Subject: Eighth Six-Month Status Report in Response to March 12, 2012 Commission Order Modifying Licenses with Regard to Reliable Spent Fuel Pool Instrumentation (Order Number EA-12-051)

James A. FitzPatrick Nuclear Power Plant
Docket No. 50-333
License No. DPR-059

**James A. FitzPatrick Nuclear Power Plant's (JAF's) Eighth Six-Month Status Report for
the Implementation of Order EA-12-051, Order Modifying Licenses with Regard to
Requirements for Reliable Spent Fuel Pool Instrumentation**

POOL LEVELS AND REFERENCES

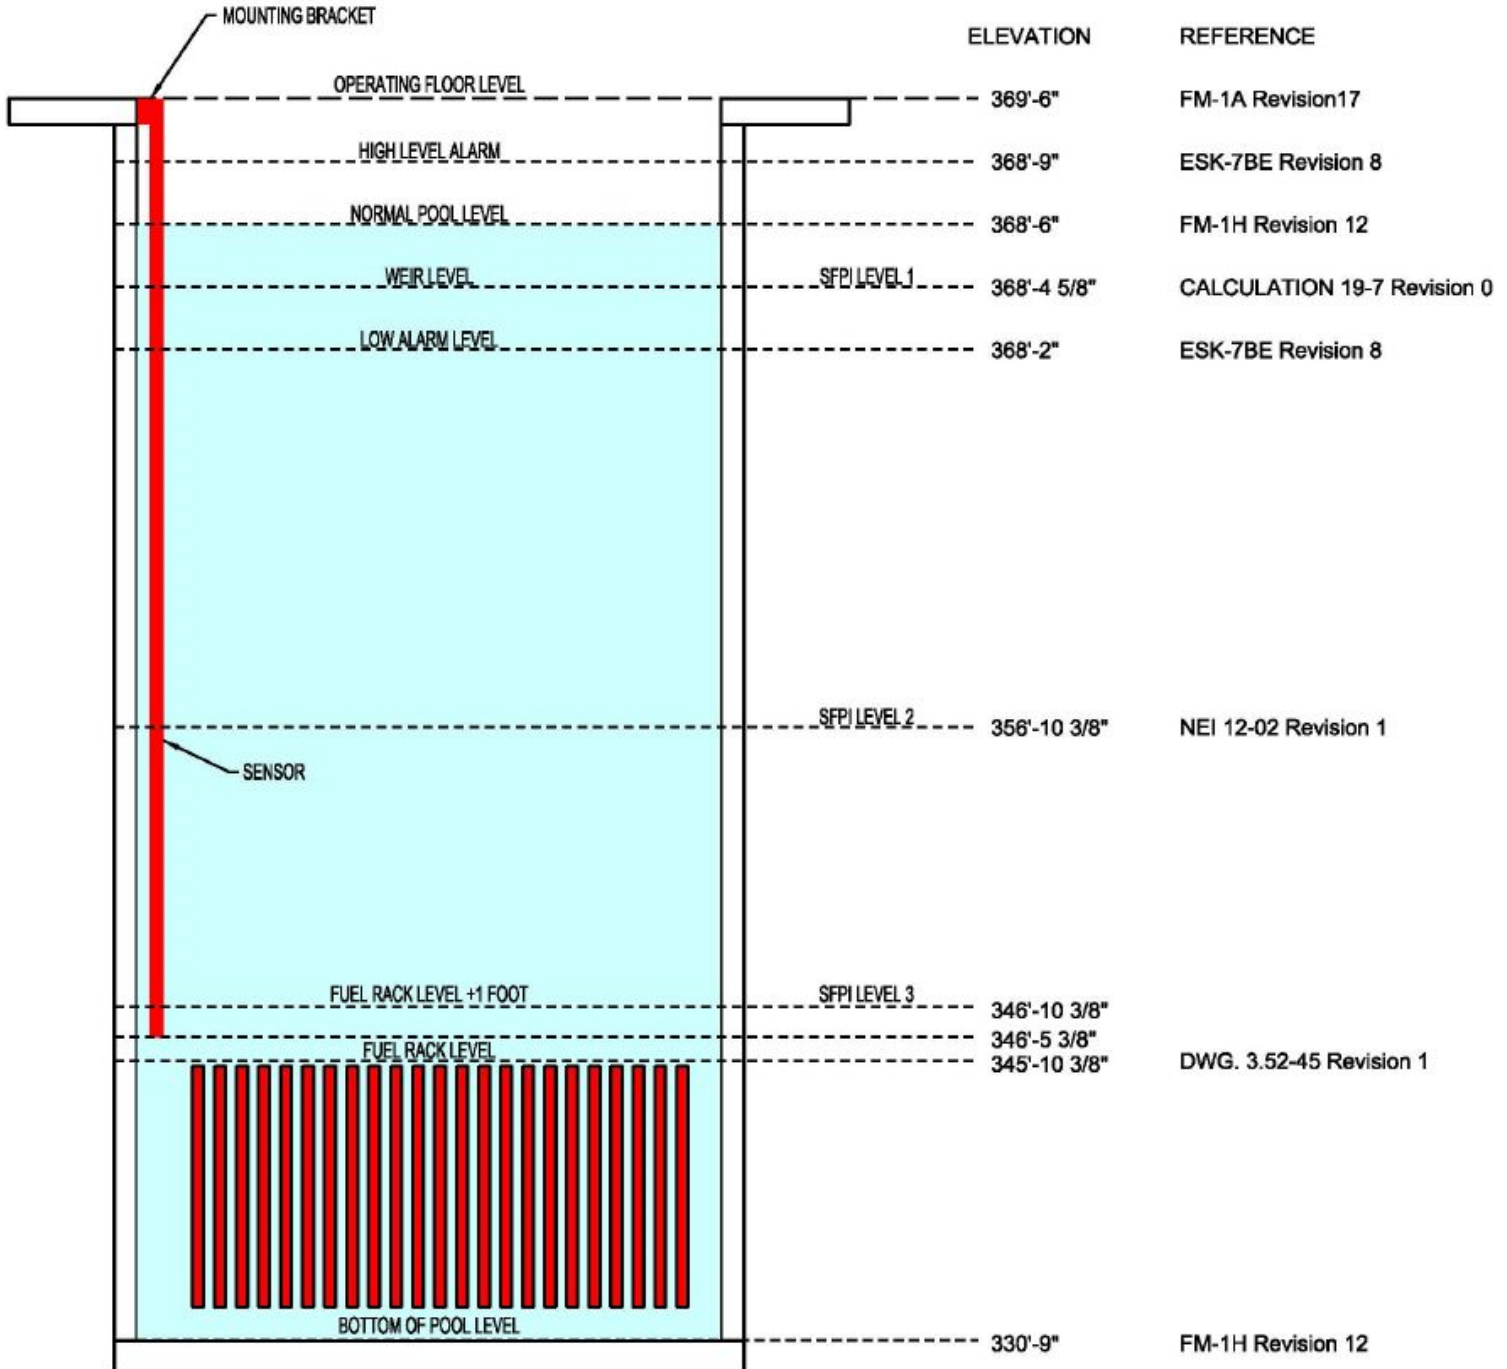
The final SFPI design makes several minor dimension changes to the probe elevation and level designations, which are captured in ECN 67191 (Reference 16). The revised probe elevation resolves a discrepancy of 1" between the specified procurement flange elevation and the as-built flange elevation. Bracket mounting calculation JAF-CALC-15-00005 (Reference 15) was reviewed and is still bounding.

SFPI Level 3 is now defined as 1' above the fuel racks (346'-10 3/8"), for consistency with the Entergy fleet. It was previously defined as 6" above the fuel racks during the design phase. Subsequently, Level 2 is now defined as 10' above the Level 3 definition (11' above the fuel racks). All elevations meet the NEI 12-02 guidance for Levels 2 and 3.

The elevation of the bottom of the probe based on the as-built flange height and final SFPI Levels 1, 2, and 3 are included in the figure below.
